Addendum 47 – UN Regulation No. 48

Revision 13 - Amendment 6

Supplement 5 to the 07 series of amendments – Date of entry into force: 24 September 2023

Uniform provisions concerning the approval of vehicles with regard to the installation of lighting and light-signalling devices

Model A

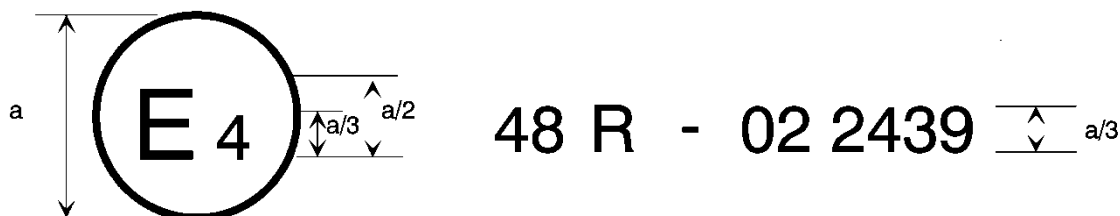
Annex 2, amend to read:

a = 8 mm min.

The above approval mark affixed to a vehicle shows that the vehicle type concerned has, with regard to the installation of lighting and light-signalling devices, been approved in the Netherlands (E4) pursuant to UN Regulation No. 48 as amended by the 07 series of amendments. The approval number indicates that the approval was granted in accordance with the requirements of UN Regulation No. 48 as amended by the 07 series of amendments.
